Access Compliance Report

Public Rights-of-Way

(Curb Ramps)

Intersection ID: N/A	Main Street: YORK_CENTER	Cross Street: N/A	Location: SE
ADA ID: D6DD48863E53	Ramp Type: Directional2	Initial Pass/Fail: Fail	Overall Compliance: No
			Severity Score: 13.75

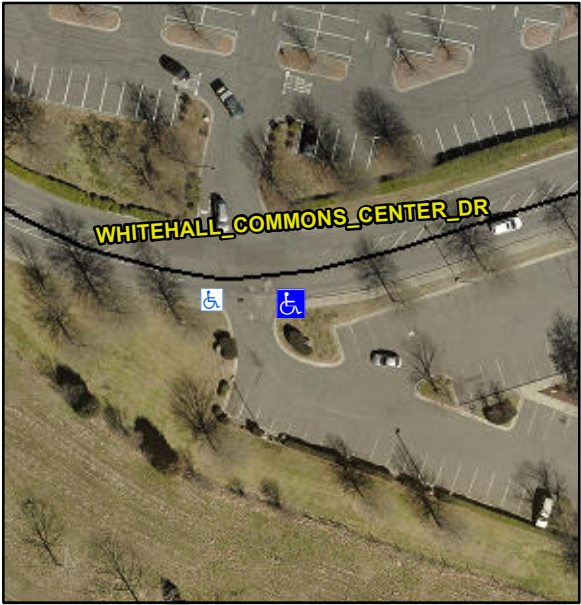
Codes/Mitigation Info/Possible Solution			Field Measurements/Component Compliance			
 <p>Street 1 Name WHITEHALL COMMONS CENTER DR</p> <p>Stop Condition-Street 1 None</p> <p>Street 2 Name N/A</p> <p>Stop Condition-Street 2 N/A</p>	Possible Solutions:		Compliance	Description	Data	
	Remove & Replace Entire Ramp.		N/A	Ramp Length (in)	62.0	N/A
			Yes	Ramp Width (in)	60.0	N/A
			No	Ramp Slope (%)	10.2	N/A
			Yes	Ramp XSlope (%)	4.9	N/A
			N/A	Flare Type LT	N/A	N/A
			N/A	Flare Slope LT (%)	N/A	N/A
			N/A	Flare Traversable LT?	N/A	N/A
			N/A	Landing Length (in)	0.0	N/A
			N/A	Landing Width (in)	0.0	N/A
			N/A	Landing Slope (%)	0.0	N/A
			N/A	Landing X Slope (%)	0.0	N/A
			N/A	Landing Curb? (Y/N)	N/A	N/A
			N/A	Shared Landing?	N/A	N/A
			N/A	Gutter Ponding?	0.0	N/A
			N/A	Gutter Lip Ht (in)	0.0	N/A
			N/A	Painted X Walk1?	No	N/A
				X Walk 1 Direction	To W	N/A
				X Walk 1 Width (in)	N/A	N/A
				X Walk 1 Slope (%)	1.5	N/A

X Walk 1 X Slope (%)	5.2	N/A
<p>Surveyor Notes:</p> <p>N/A</p> <p>PROW/ADA:</p> <p>R304.2.2</p>			N/A	Ramp inside XWalk1?	N/A	N/A
			N/A	Any Obstructions?	N/A	N/A
				Obstruction Type		N/A
Total Cost: \$ 1800.00						
			Yes	Surface Condition? (G/P)	Good	
			N/A	Curb Slope (%)	0.1
